**ADDENDUM #1
CLARIFICATION**

**CIP - LAKEVIEW HEALTH CENTER
EXTERIOR UPGRADES
2849-61 NORTH CLARK ST.
CHICAGO, ILLINOIS 60657
PBC PROJECT NUMBER 04031**

**SUBJECT: CIP - LAKEVIEW HEALTH CENTER EXTERIOR UPGRADES
BID PACKAGE #1R – ADDENDUM #1**

**NOTICE OF CHANGES, MODIFICATION, OR CLARIFICATIONS
TO CONTRACT DOCUMENTS**

14 PARAPET WALL FLASHING DETAIL AT CLARK ST.
SCALE: 3/4" = 1'-0"

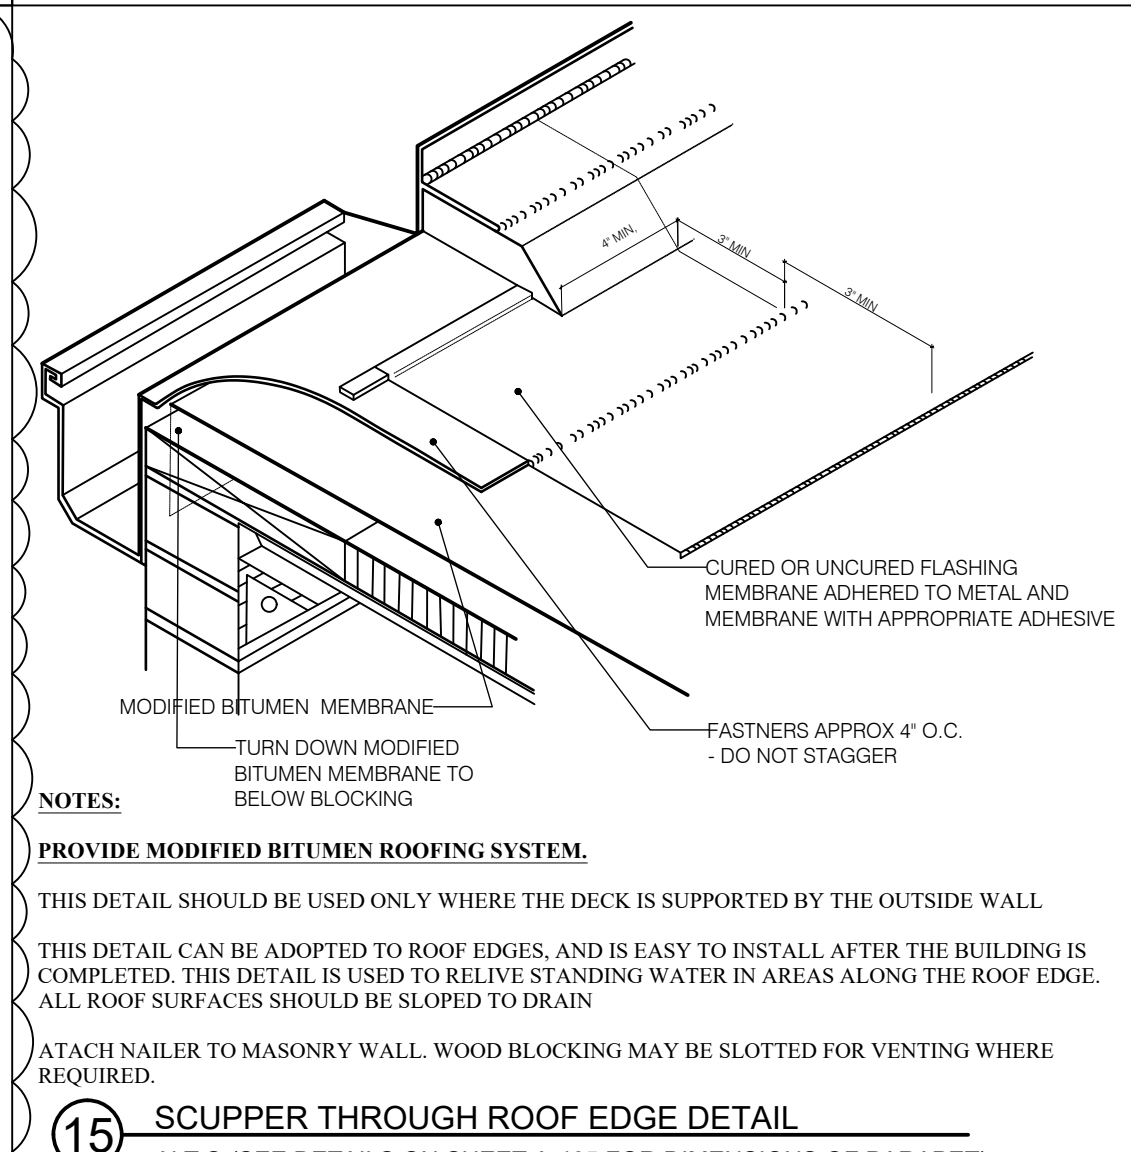
3. Can the existing roofing report be forwarded so bidders can provide an accurate estimated time frame for the roof removal? **Roofing report is attached for reference.**
4. How is flashing done at existing metal behind parapet wall on Clark St? **Please see Detail 14 on updated Sheet A-105.**
